## DECISION OF THE PLANNING COMMISSION

**CLASS 3 DESIGN REVIEW / CONDITIONAL USE / CLASS 3 SITE PLAN  
REVIEW / CLASS 2 ADJUSTMENT / CLASS 2 DRIVEWAY APPROACH PERMIT  
CASE NO.: DR-CU-SPR-ADJ-DAP18-01**

**Summary:** A consolidated application for a Conditional Use Permit, Design Review, Site Plan Review, Driveway Approach Permit, and Class 2 Adjustment to allow for the development of a proposed retail commercial development with a drive-through on property located at 3994 Portland Road NE.

**LOCATION:** 3994 Portland Road NE / 97301

OVERALL SITE  
PLAN

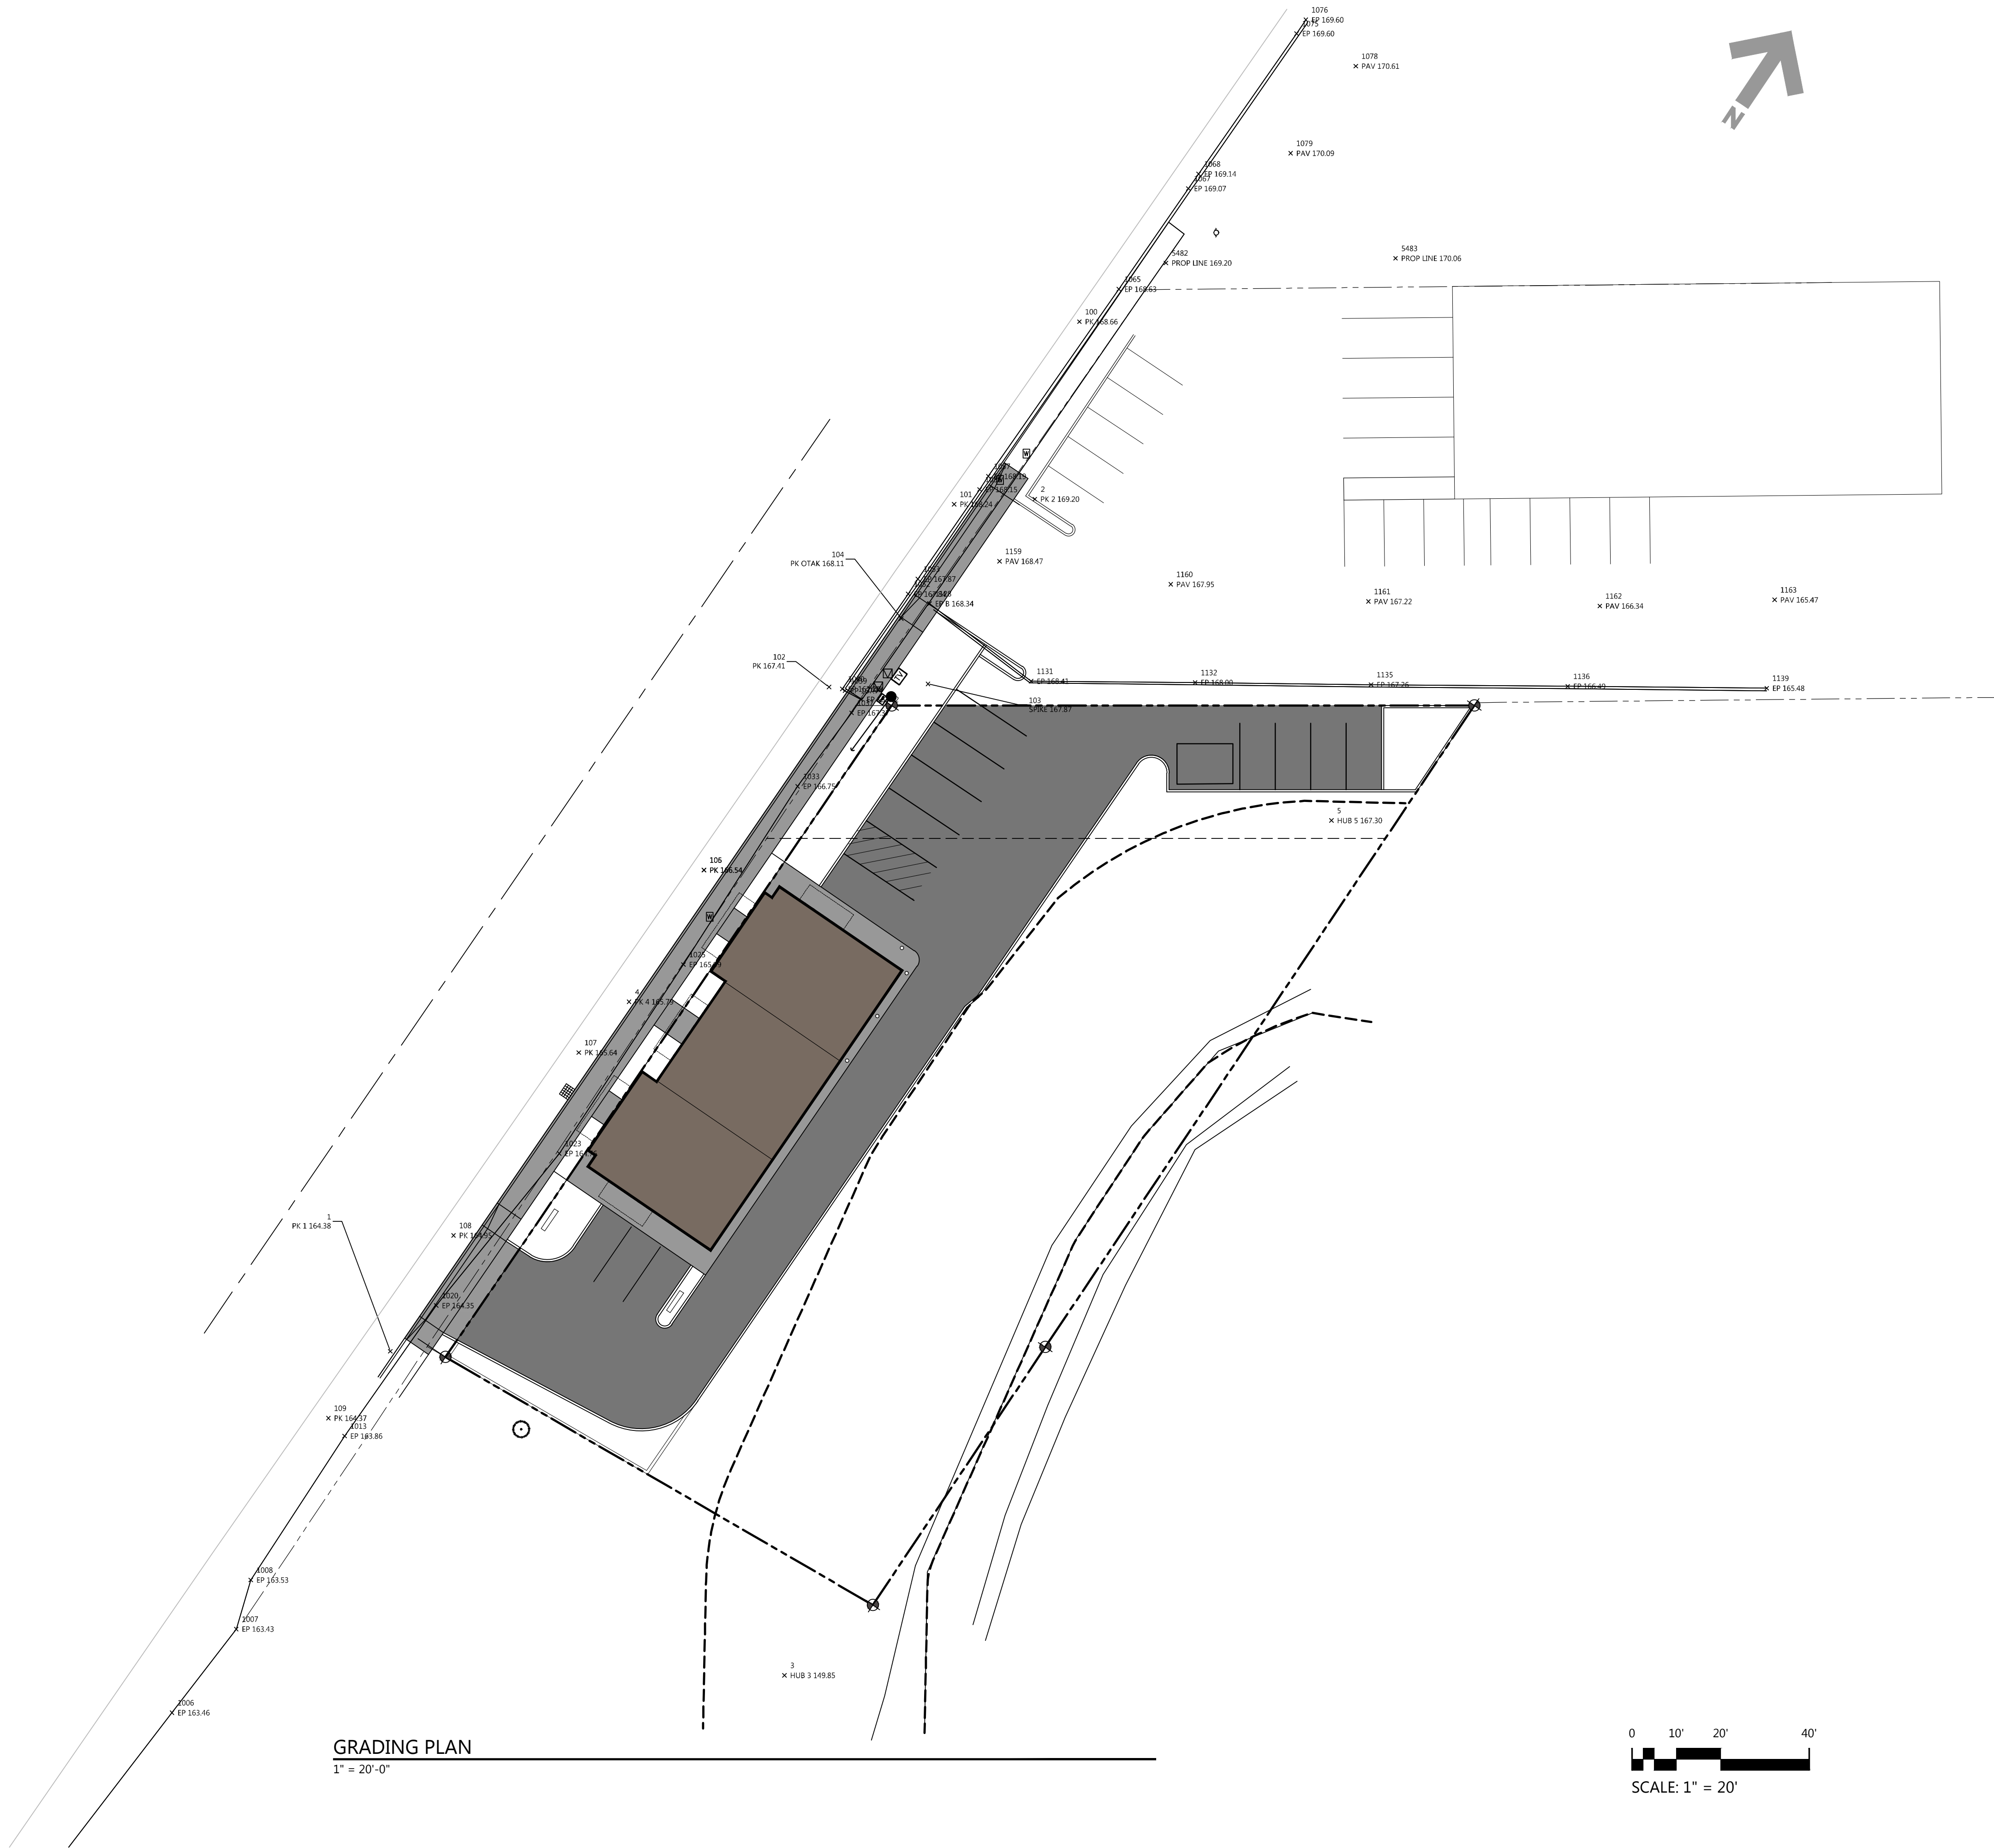
- Condition 2:** The internal pedestrian connections along the north and south sides of the building shall be revised to connect to the public sidewalk along Portland Road NE and shall maintain a minimum width of five feet.

- Condition 3:** The site plan shall be revised to provide a direct pedestrian connection, which is a minimum of five feet in width, from the loading area adjacent to the ADA parking space to the public sidewalk along Portland Road NE.

**Finding:** The proposed commercial development requires a minimum of four bicycle parking spaces. The site plan submitted into the record not show bicycle parking on the proposed site plan, to ensure this standard is met, the following condition of approval shall be met:

**Condition 2:** The internal pedestrian connections along the north and south sides of the building shall be revised to connect to the public sidewalk along Portland Road NE and shall maintain a minimum width of five feet.

**Condition 3:** The site plan shall be revised to provide a direct pedestrian connection, which is a minimum of five feet in width, from the loading area adjacent to the ADA parking space to the public sidewalk along Portland Road NE.

**Condition 1:** At the time of building permit application, the applicant shall provide a revised site plan showing a minimum of four bicycle parking spaces which meet the development standards of SRC Chapter 806.060.

Date: **06/01/2018**  
Scale: **AS NOTED**  
Sheet  
**A01.0**  
Of Sheets

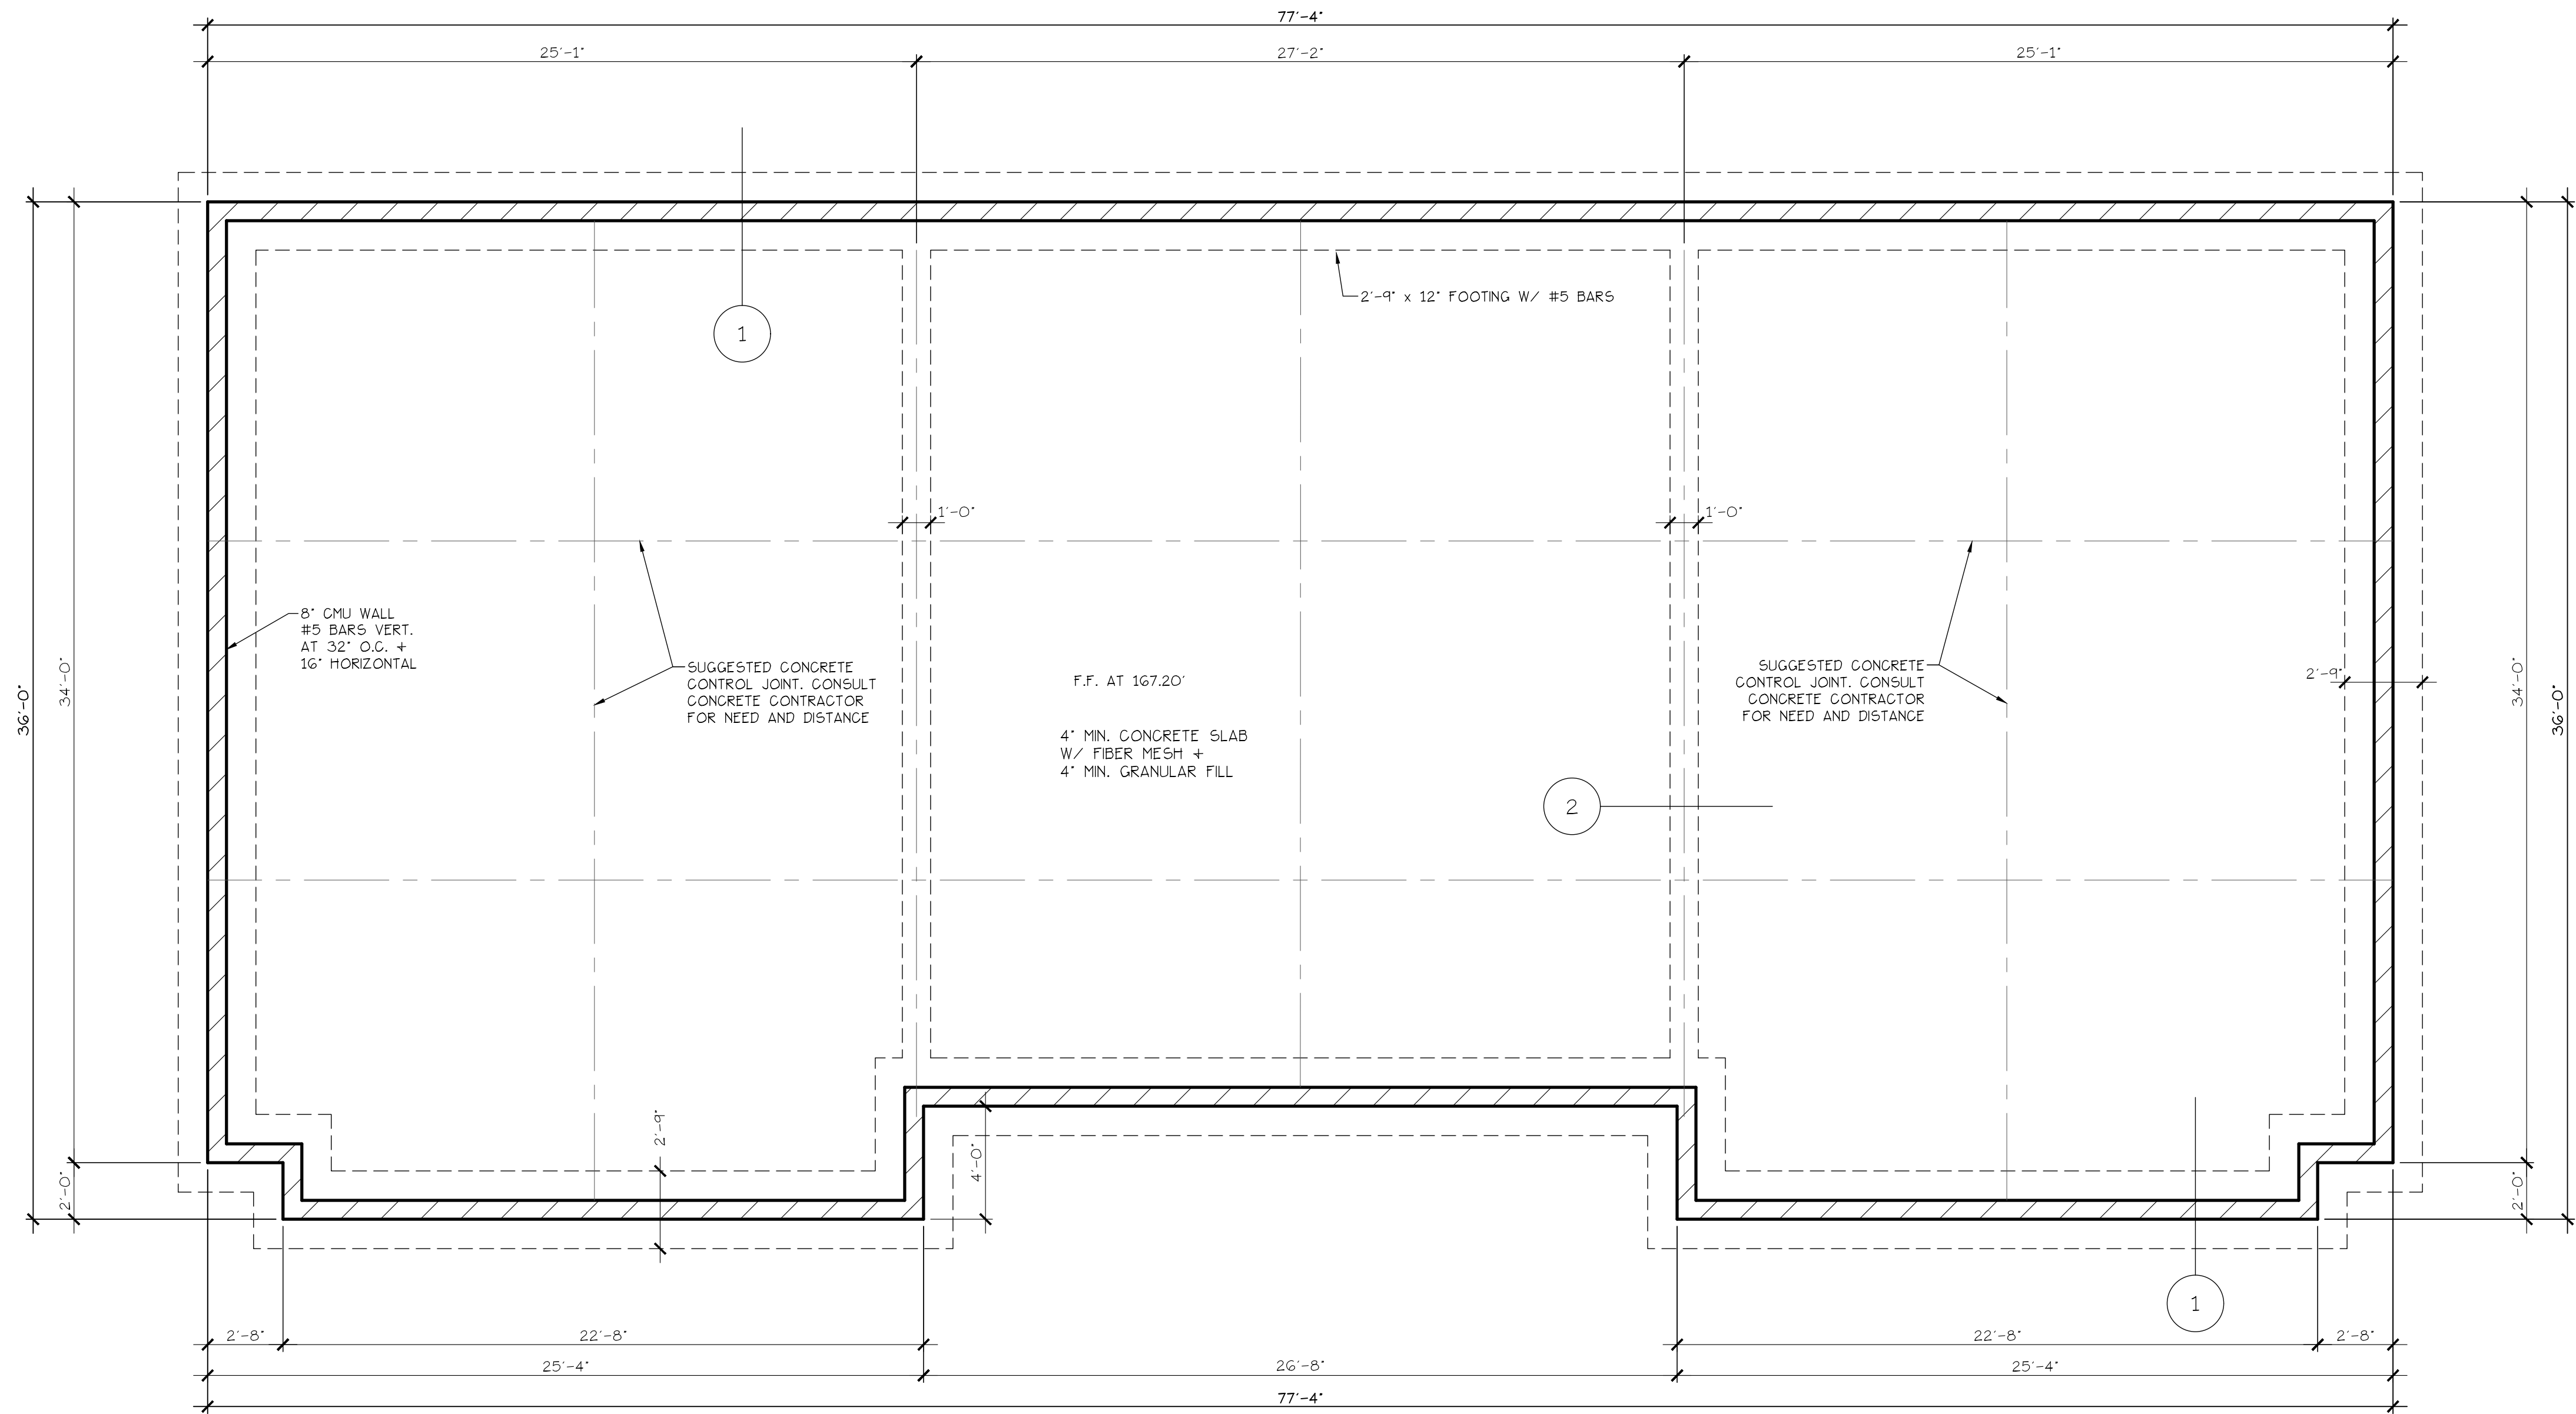
**Finding:** The building elevation facing Portland Road NE is approximately 1,300 square feet which requires a minimum 845 square feet ( $1,300 \times 0.65 = 845$ ) be comprised of transparent windows which are not mirrored or treated in any way to block visibility into the building. The record indicates that the windows will meet the standard at the time of building permit. The elevations provided by the applicant show windows covering approximately 450 square feet. The record does not include details regarding the Visible Transmittance of the windows. To ensure the standard is met, the Planning Commission finds that the following conditions shall be met:

**Condition 4:** The building design shall be revised to enlarge the windows on the west building elevation facing Portland Road NE to provide for window coverage of at least 65 percent.

**Condition 5:** At the time of building permit application, the applicant shall provide product specifications for the windows to ensure they have a minimum Visible Transmittance of 37 percent.
